Ministry of
Transportation

RE: Concord West Association Proposal for 407 Transitway Concord Station

Alternative Station Layouts

Concord (GO-Barrie) Station

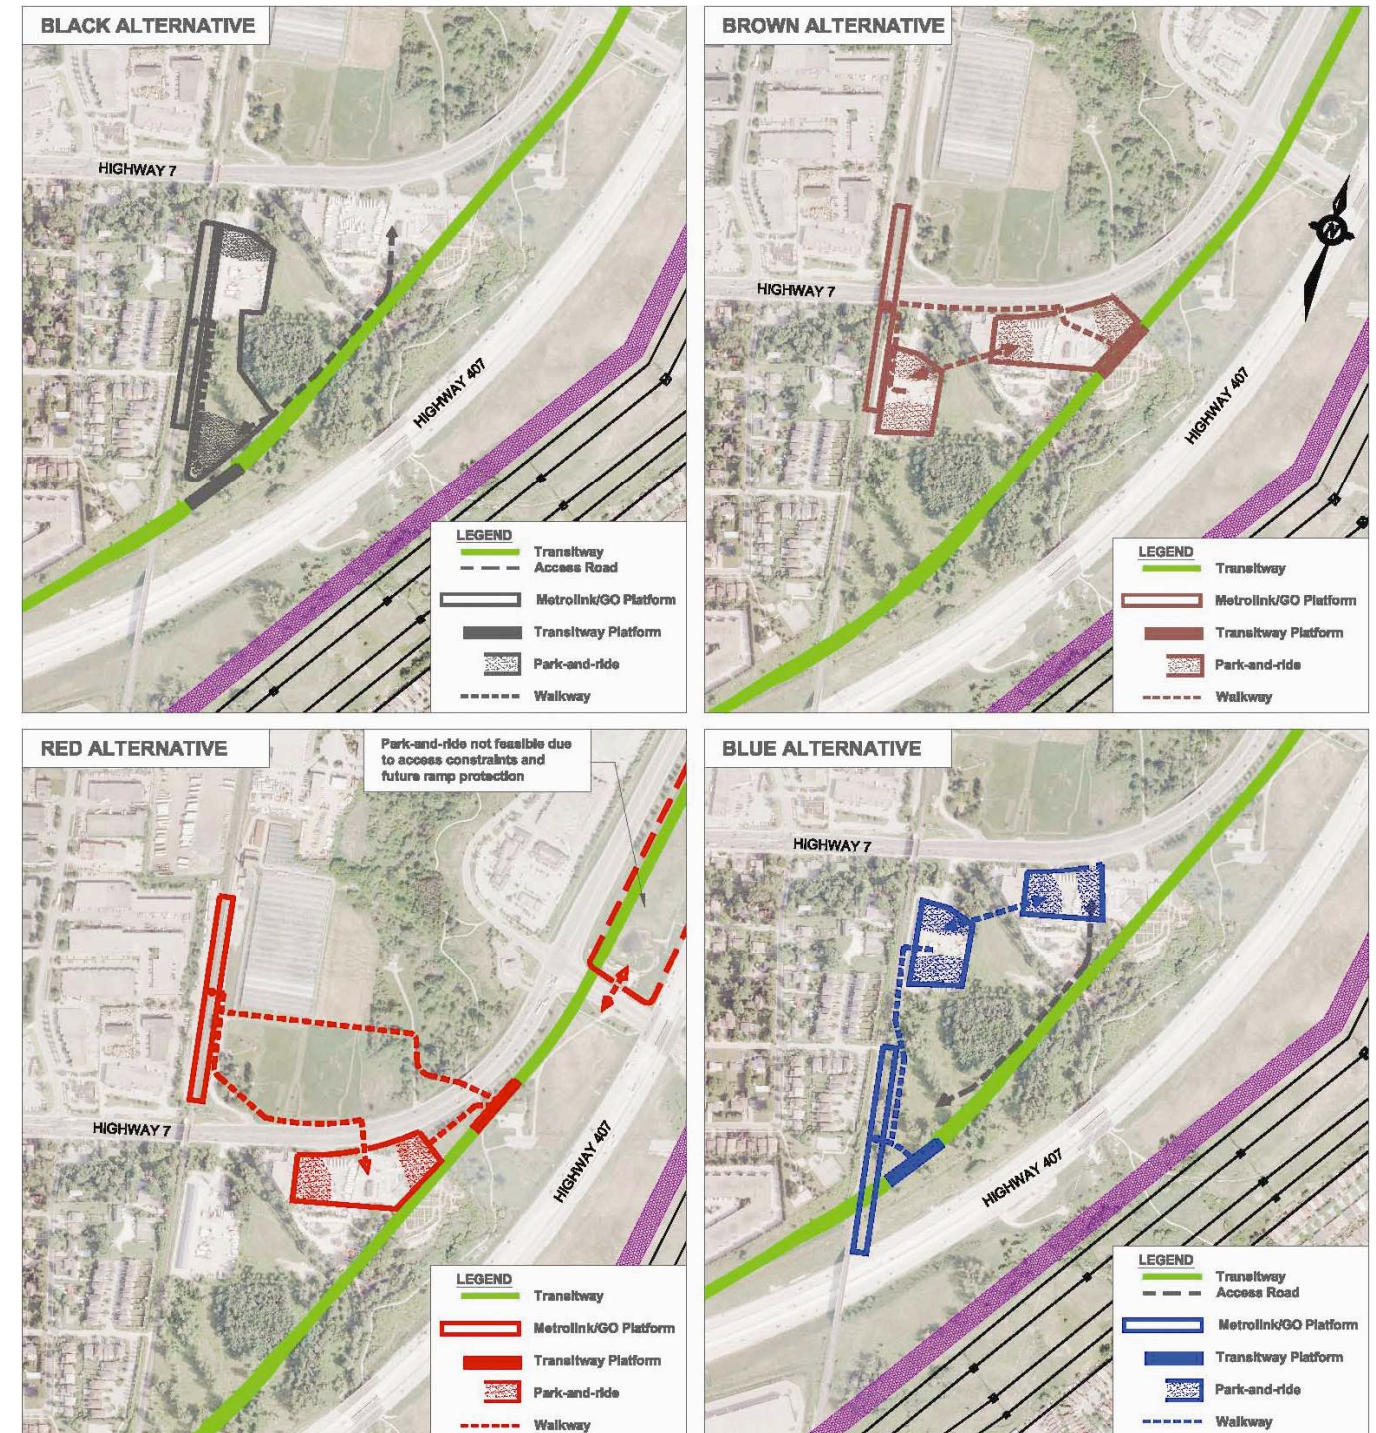
In the course of this alternatives analysis, the study team has incorporated the Concord West community's alternative proposals where feasible, basically placing the Metrolinx/GO platform north of Highway 7 and the 407 Transitway station east of the river valley towards Centre Street as in the red alternative.

The suggestion to curve the GO tracks to the east with a station on the curve is not practical as it does not meet the Metrolinx/GO alignment and station placement standards. Also, placing a park-and-ride lot north of Centre Street between Highway's 7 and 407 is not feasible as this land is being protected for a potential future ramp to Highway 407 and any access to the lot would be unacceptably close to the existing Highway 7-Centre Street intersection. MTO has included an alternative lot location further west to overcome this shortcoming and make the proposal suitable for evaluation.

Considering all factors assessed in the evaluation, the preferred Transitway/GO Rail platform configuration is the Black Alternative, with station support facilities on the protected provincial land immediately adjacent to the existing rail right-of-way. Development of this site configuration:

- Minimizes the walking distances for passengers transferring between the Transitway and GO Rail, the seamless north-south to east-west connectivity essential at this node;
- Places PPUDO and park-and-ride facilities conveniently close to platform access for both transit systems;
- Provides a reasonable parking capacity without intruding into the West Don River flood plains;
- Allows most of the natural riverbank vegetation and the adjacent woodlot to be preserved;
- Requires a support facility layout that minimizes effects on natural vegetation;
- Permits mitigation of noise and visual effects on the residential community west of the GO Line as discussed in Section 7;
- Preserves access from the residential areas to the valley lands by means of defined walkways through the station support facilities;
- Provides improved access to the Marita Paine Park Trail via the new river crossing.
